## Executive Summary

Part A – In Hydro Tasmania’s view the tightening of under frequency standards from 47.5Hz to 48Hz will not achieve a positive benefit cost as required by the AEMC terms of reference.

## Part A - Benefit Cost Analysis

## Part B - Responses to Reliability Panel Requests

**Figure 1 Contingency size duration curve FY 07/08**

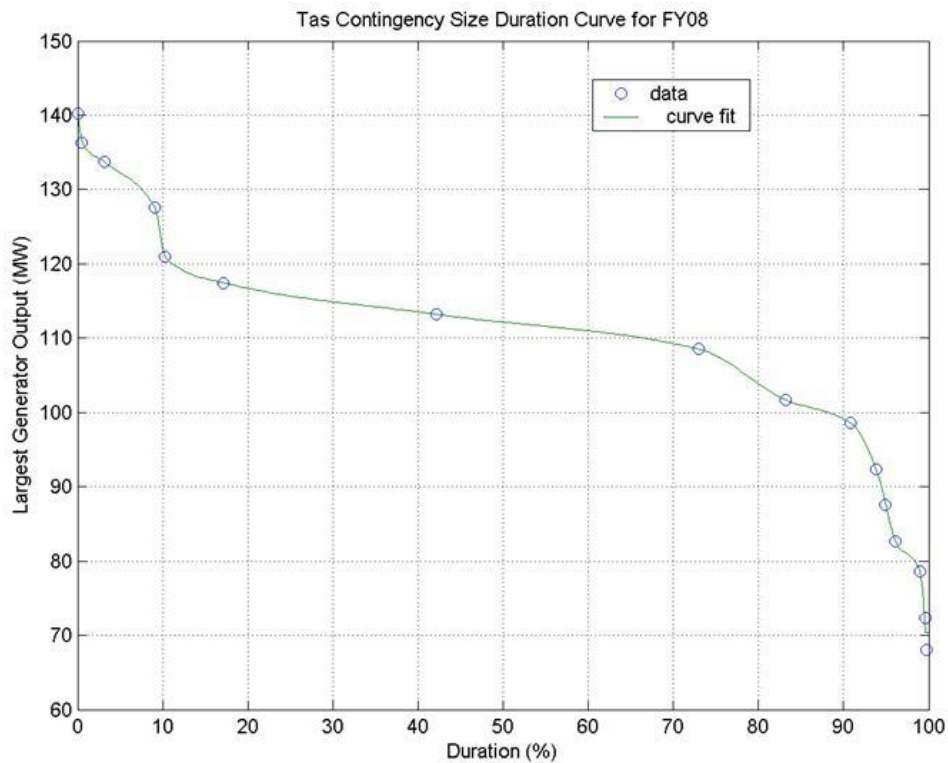
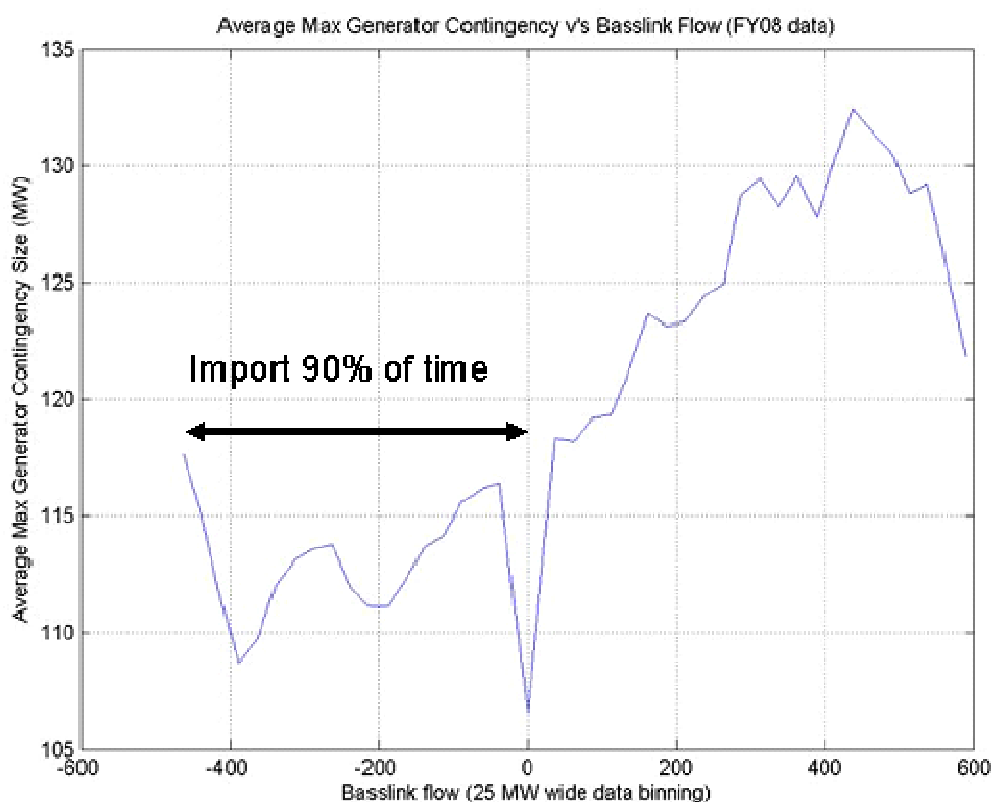
The most effective way to determine the economic availability of R6 in Tasmania is to take an historical view of dispatch. The following graphs illustrate the contingency size duration curve for 07/08 financial year and the relationship to Basslink flow. The contingency size has a direct relationship with the availability of R6.

The graphs demonstrate that the system is currently operated so that the maximum contingency is typically below 120MW import periods and below 110MW for Basslink reversals. The contingency is managed downwards at these times to avoid sub optimal dispatch due to shortages of R6. Higher contingencies are generally only economic when Basslink is in strong export (132MW avg). Hydro Tasmania typically optimises the impact of the requirement by reducing the maximum contingency overnight and prior to a Basslink reversal. When TVPS is commissioned, this management of the largest contingency by Hydro Tasmania will no longer be possible and the effective volume of R6 required will be increased relative to current requirements.

Hydro Tasmania made strong representation that a 144MW limit for Tasmania should be included in the frequency standard and is still supportive of such an approach. However, due to the analysis of current and future capability would recommend a transitional measure be applied to TVPS that allows time to develop further capability in the region. This transitional measure would limit TVPS to a contingency size equal to the next highest contingency (up to 144MW) or 115MW whichever is the greater. This arrangement could be reviewed at regular intervals (e.g. annually) and should only apply for a maximum of 3 years.

**Figure 3 Cost of providing additional R6 in Tasmania**

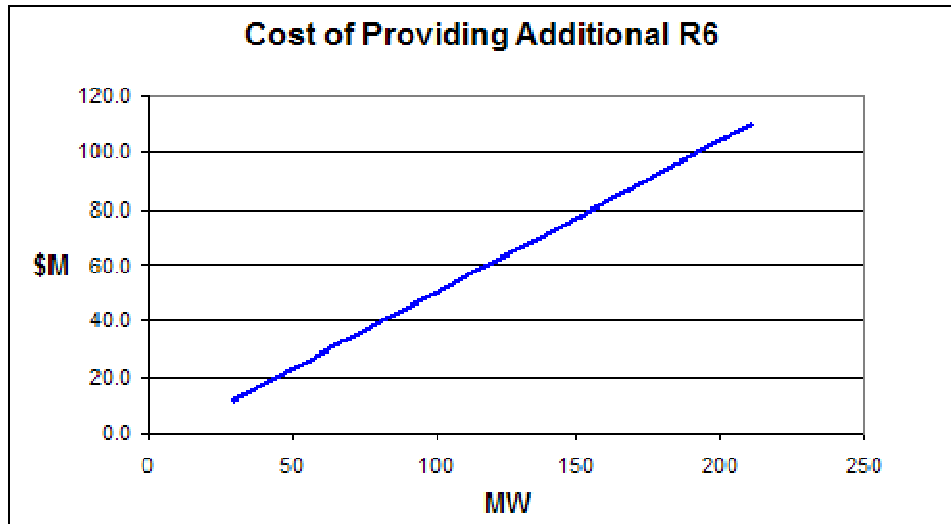
However, all of these will take some time to develop and become progressively more expensive to provide. The graph below shows the capital cost for the supply curve for additional R6.

If Hydro Tasmania were to embark on a work program to increase R6 availability using its existing plant the time frame for such work is likely to extend well beyond TVPS commissioning. The table below contains the most economic projects (note: at least half would be required to off-set increase in requirement for a constant 144MW contingency based on these estimates).

**Figure 1: Graph showing comparative R6 requirements between 210MW and 144MW contingency for 47.5Hz frequency standard**

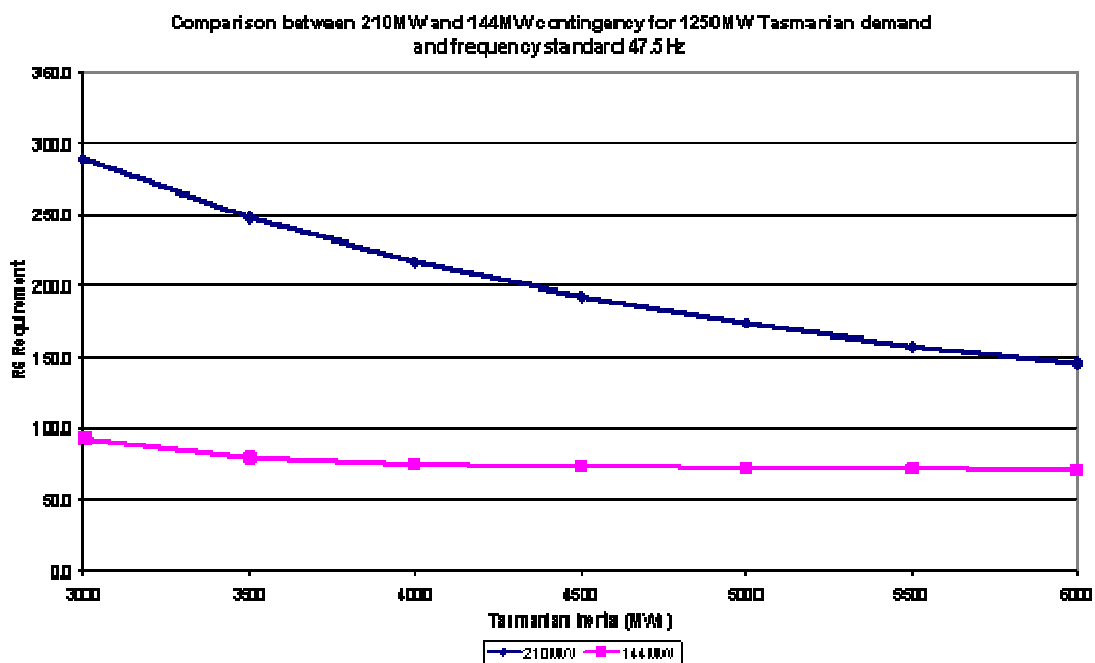
There is general consensus that TVPS contingency size should be limited to 144MW (or less?) during periods of low Tasmanian demand and low inertia due to the excessive amounts of R6 that would be required to satisfy a generating unit event. Insufficient local (Tasmanian) R6 would then typically result in Basslink being constrained, either near the no-go zone or in respect of its potential import target, to permit global FCAS transfer. The graph below is a reminder of the difference in R6 requirement for an average Tasmanian demand (1250MW) with 144MW and 210MW contingencies.

We note from the graphs that the difference in R6 varies from around 75MW at 6000MWs inertia to nearly 200MW at 3000MWs inertia. Referring to Reference 1<sup>4</sup>, Figure 1, we note that the average R6 in dispatch is around 70 to 80MW (assume 80MW). With these numbers in mind, Basslink is at risk of being constrained when energy prices require increased southern flow on Basslink (i.e. reduced export or increased import) under the following scenarios:

The discussion above shows that it will not be possible to calculate a contingency size based simply upon Tasmanian demand and inertia as this does not in the first instance take into account the discontinuity in reversing Basslink (reducing export). Secondly, the extent of impact upon Basslink import is such as to suggest that TVPS should remain at 144MW (or below) for Basslink anywhere between import and around 300MW export.
